Plan Commission

Monday, June 24, 2019

SUBJECT: Staff recommendation and possible action regarding a Precise Implementation Plan (PIP) for 1881 Southbridge Road (Parcels WD-1831 through WD-1838). Submitted by Brandon Robaidek, EIT, authorized representative for Crosspoint Church INC ETAL, property owner.*

PRECISE IMPLEMENTATION PLAN – 1855 - 1881 SOUTHBRIDGE ROAD

SHEET NO.
6

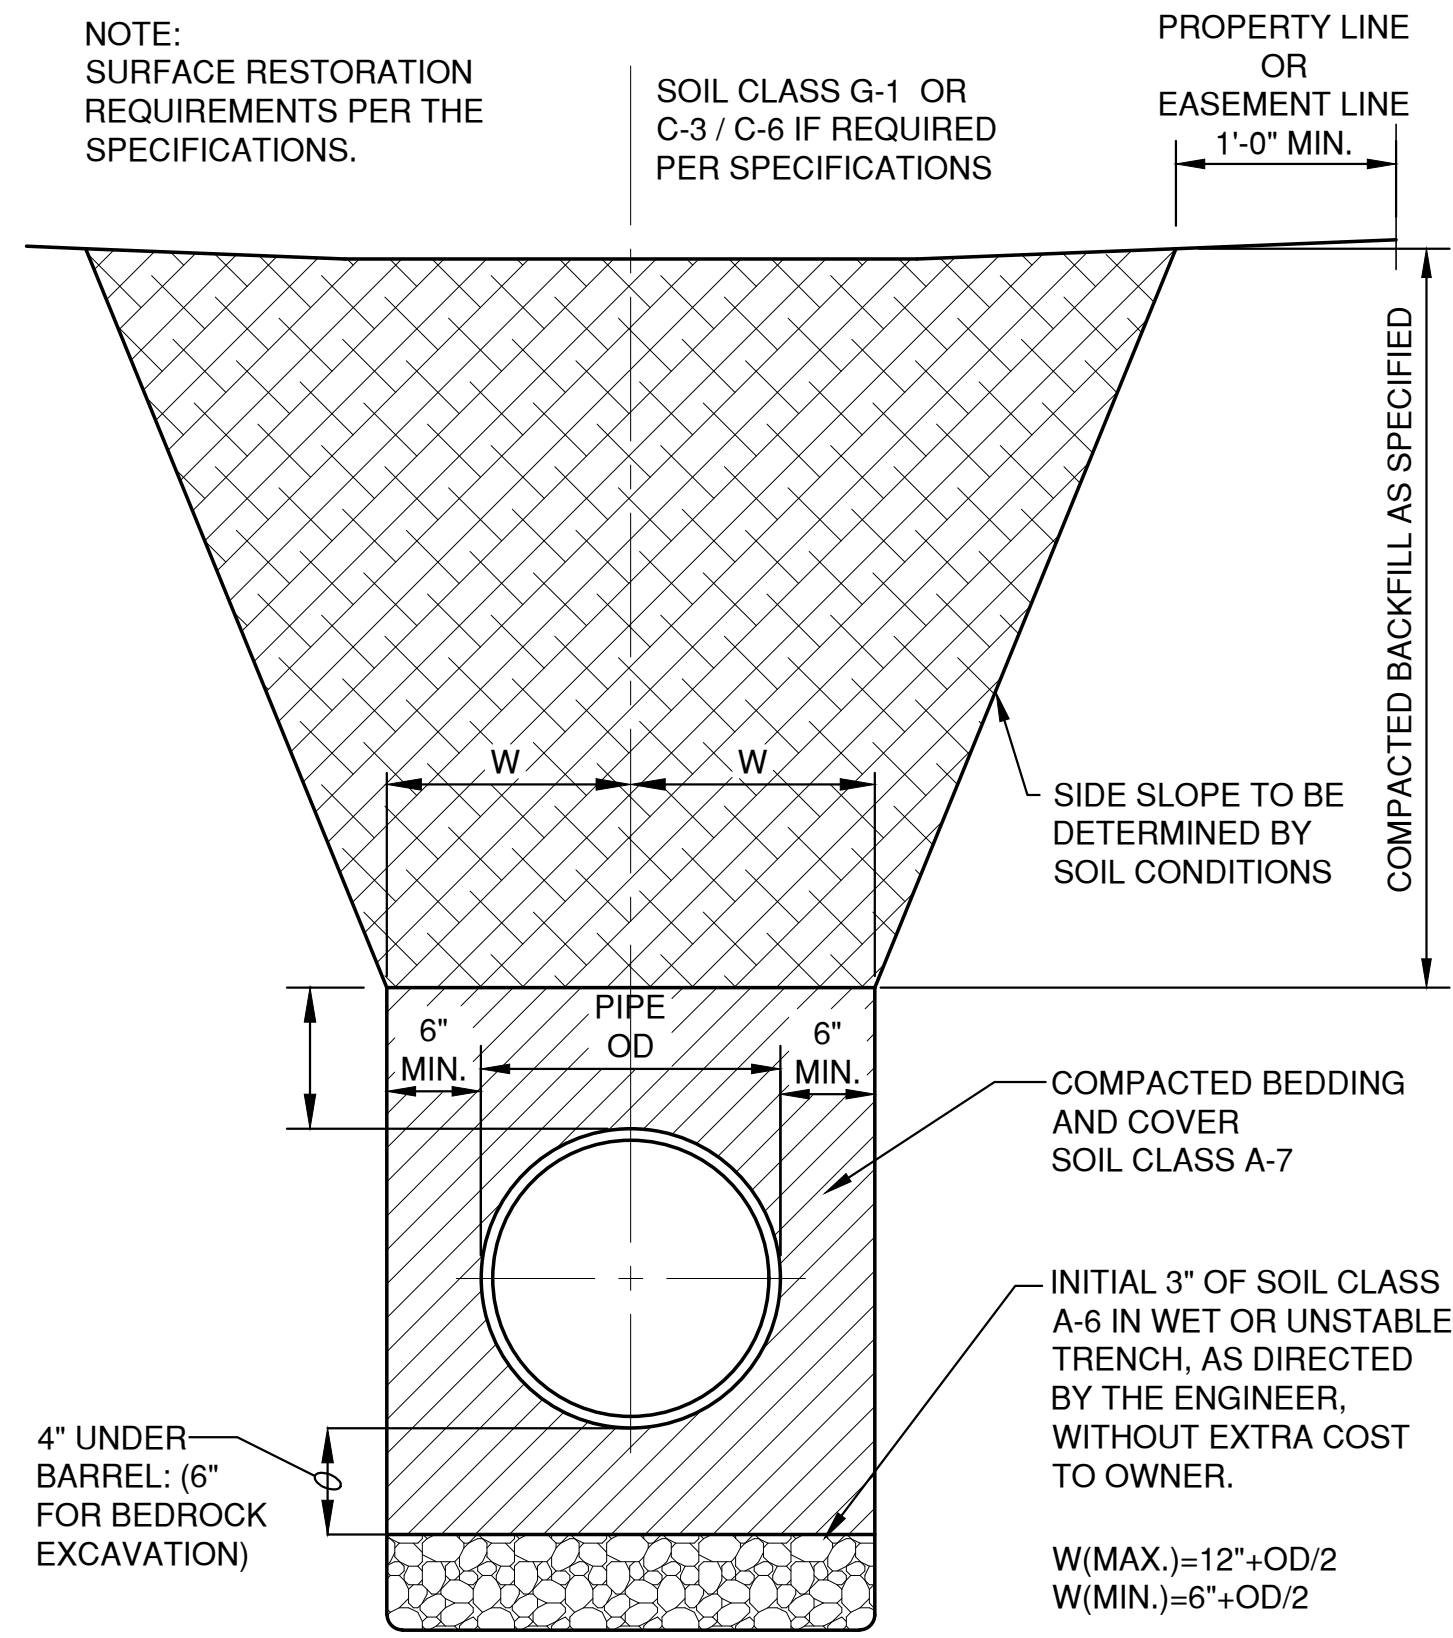
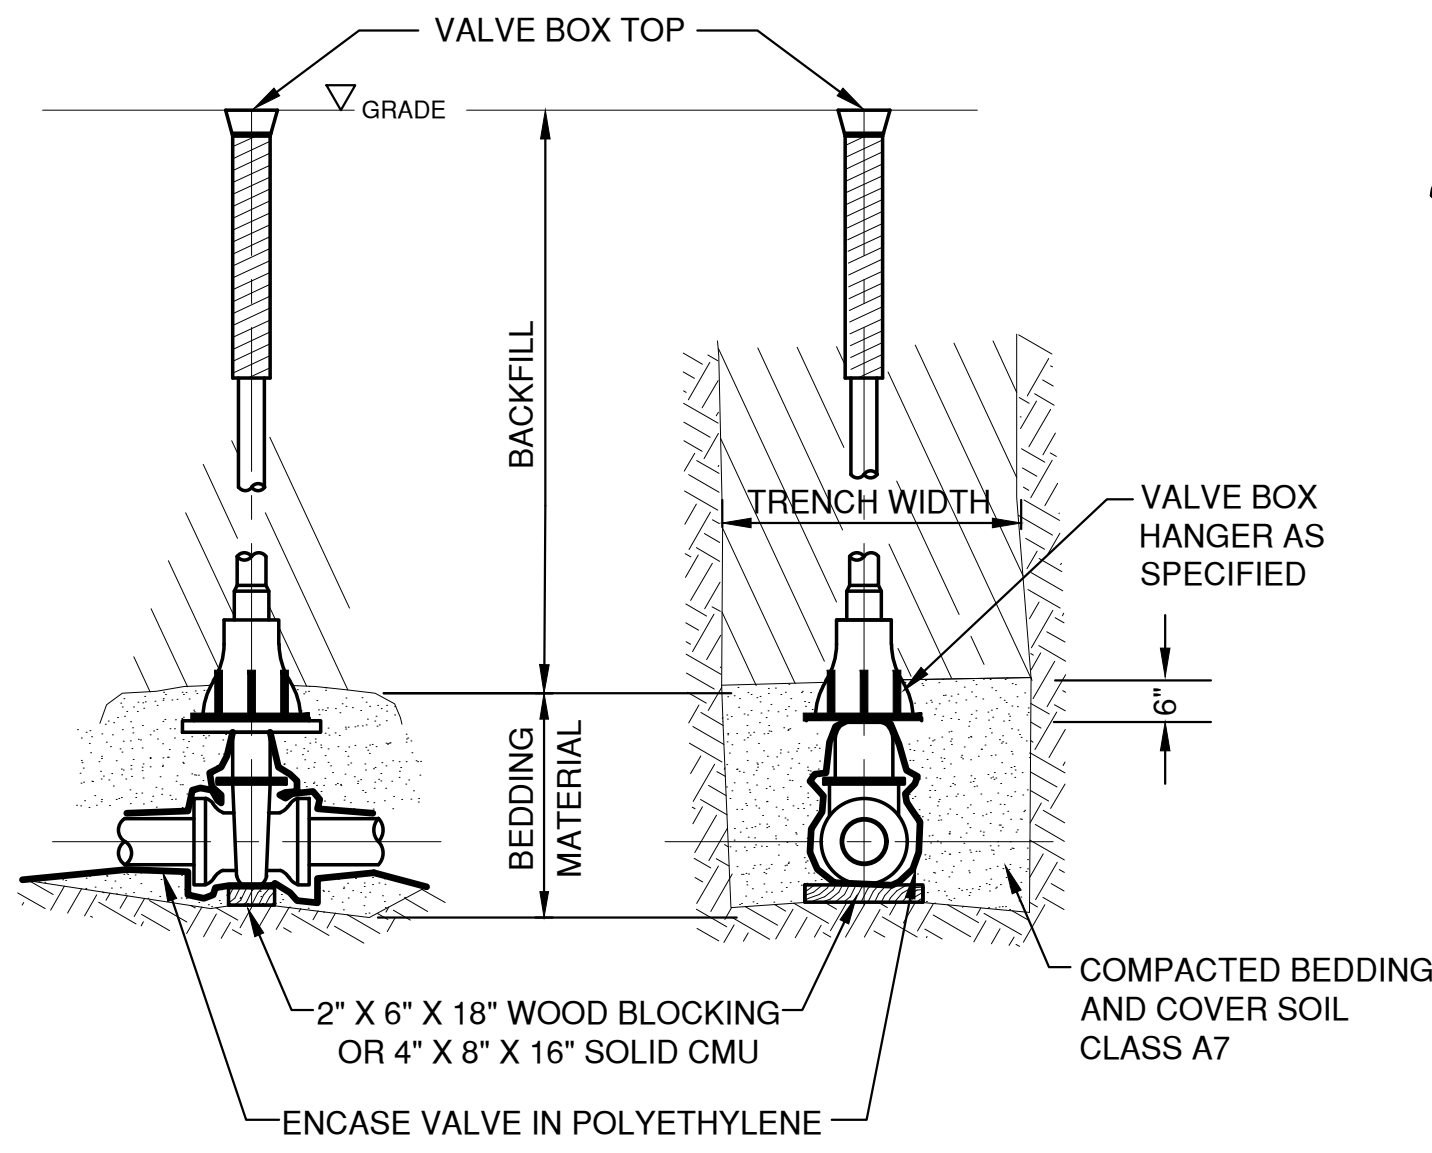
- b. Sheet 6: May want to consider anchoring end wall to connecting pipe. This is required plus rip rap and geotextile fabric
